REMARKS

In paragraph 2 of the Office Action, the Examiner rejected claims 1-7 under 35 U.S.C. 112, second paragraph, as being indefinite for failing to particularly point out and distinctly claim the subject matter which applicant regards as the invention.

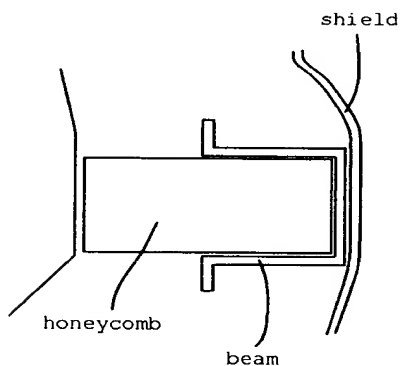
The present invention provides an improved energy absorption device which comprises a honeycomb structure having at the top, a stiff containment element made of a high tensile material such as steel. The containment element is sized to withstand the stress of an impact and the resulting lateral thrust that is generated by the honeycomb structures when they are impacted by a force applied to the beam element.

The following sketches compare the prior art with the claimed invention:

Prior art

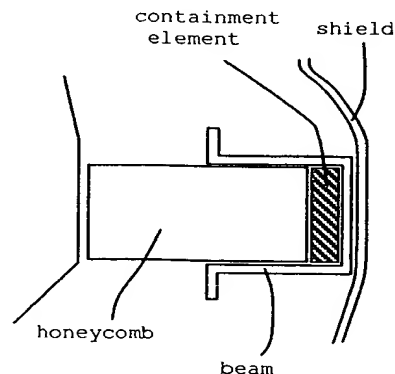
Goupy et al. discloses an energy absorbing beam (1) inserted within a shield (3) and disposed between the energy absorbing elements (2) and the shield (3). Goupy et al. does not disclose the use of a containment element according to the invention. The beam of Goupy et al. merely discloses a structure that disperses the impact forces over the honeycomb support structure. The honeycomb structure of Goupy et al. is not capable of resisting lateral thrusts that develop as the honeycomb absorbs an impact force that is received from the beam element. The containment structure, which is not suggested by Goupy et al., operates to prevent the lateral collapse of the honeycomb. Figs. 3 and 5, of the present application, show the benefits of the containment structure when the honeycomb is impacted with force.

When the beam in the Goupy et al. design is subjected to an impact force, there is no containment element to prevent lateral movement of the honeycomb along the longitudinal axis of the beam. The containment structure of the present invention functions as a "cap" to prevent movement along the longitudinal axis of the beam. The Goupy et al. beam does not provide or disclose any means for providing a containment effect with regard to lateral thrusts that are generated by direct impact on the beam element.

Fig. 2 of Goupy et al. shows the absence of any element which would be capable of restricting lateral movement of the end of a collapsing honeycomb 2, along the longitudinal axis of the beam 1. This is the movement that is prevented by the use of the applicant's containment structure. The Goupy et al.
